**Building Plan Check Invoice : BLD03-4206**

Minor revisions to approved plans Prior to Construction  
**22111 Signaigo Way,**  
**Timber Cove CA**  
 Reference plans dated 1/19/04 & approved application No. BLD03-4206  
 No change is proposed in interior floor area or the energy design.  
 Two windows & one door are relocated  
 Floor framing is altered  
 No change to lateral force resisting system  
 Foundation is revised  
 Geotechnical engineer has reviewed these changes and stated that a new plan review letter is not required.

Proposed Remodel  
 [Minor revisions to approved plans Prior to Construction]

22111 Signaigo Way  
 Timber Cove, Sonoma County, California apn 109 400 005  
 Randall & Lana Baselt, owners, POB 8299, Foster City, CA 94404

**Ground Floor Plan - R-3**

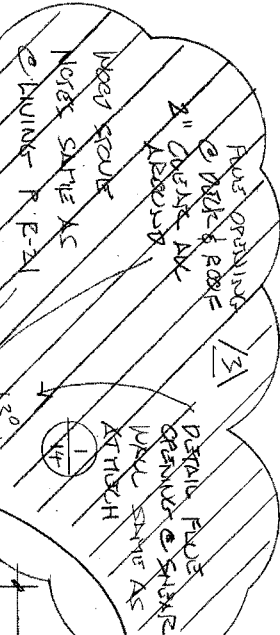
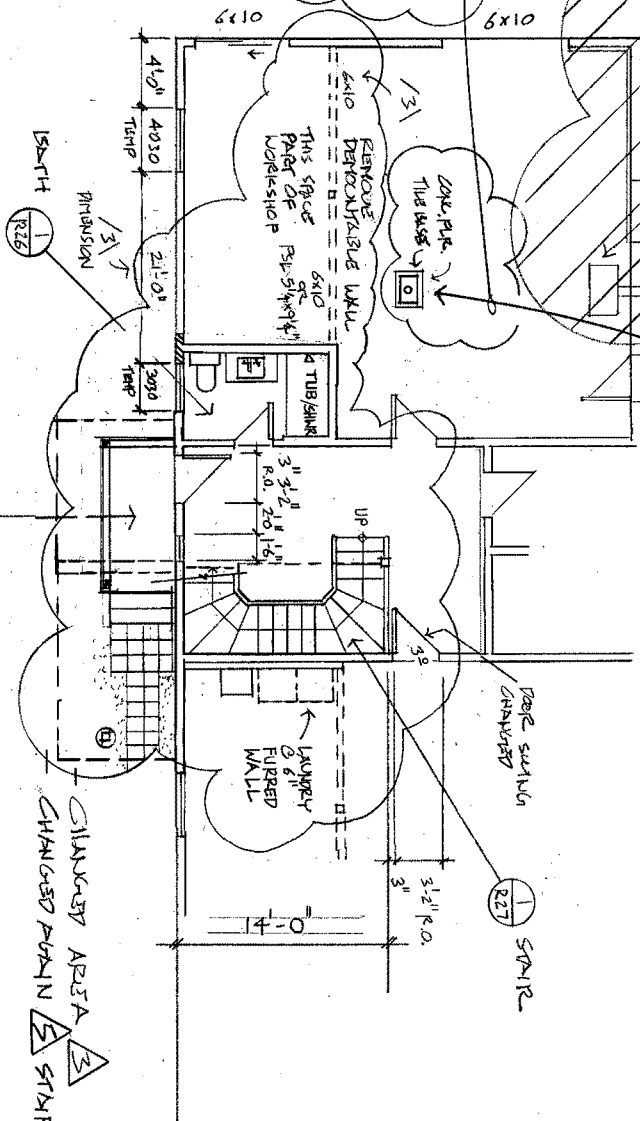
**/5\ Wood stove notes**  
 - Morso model 7110,  
 EPA II rated  
 On raised tiled base  
 with concrete floor  
 all around & 6 inch  
 single wall flue to  
 ceiling box; double  
 wall through furred  
 space in pantry and  
 attic w/2" clearance  
 to combustibles and  
 draft stop at ceiling  
 line, to spark  
 arrester at roof

CLUSTER - AND WOOD STOVE  
 RELocate WOOD STOVE TO INTERIOR

CHANGED AREA  
 CHANGED FROM 5 STAIR, NO CLOSET

Second Floor Plan - R-4

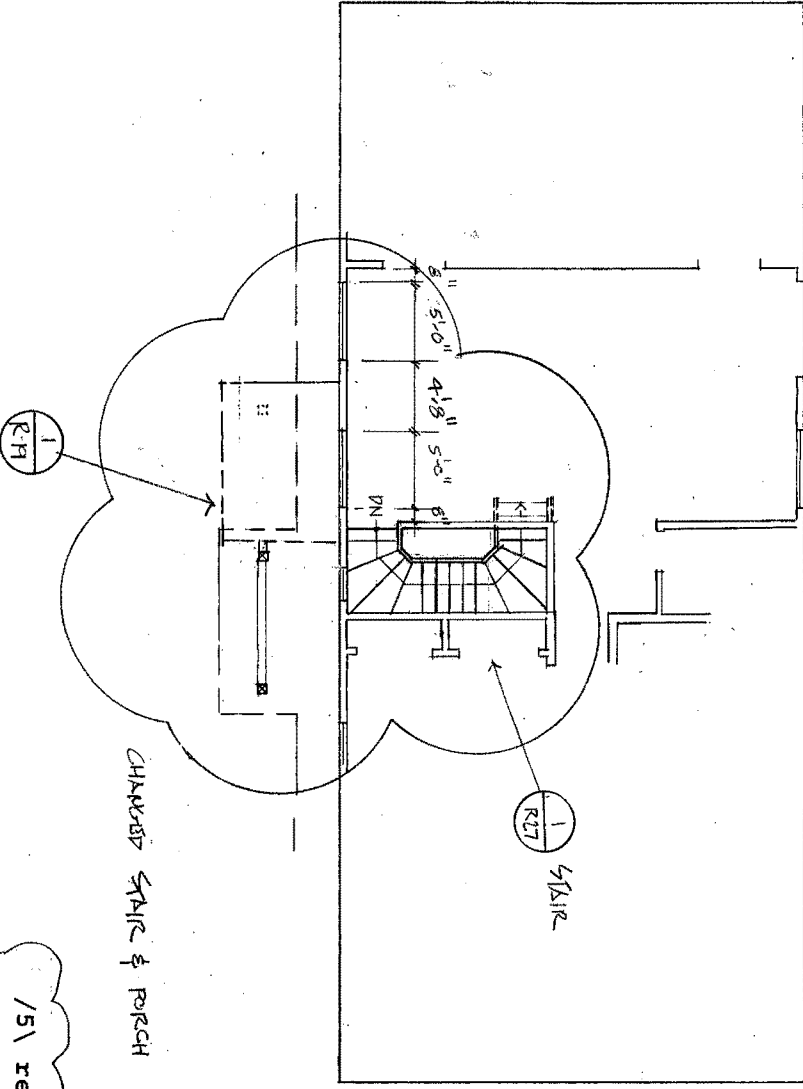
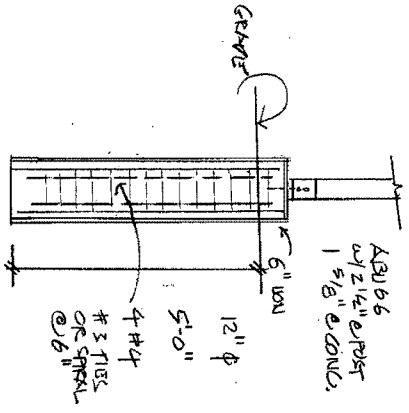
2 DECK & PORCH POST  
R-4 FOUNDATION 1/2"
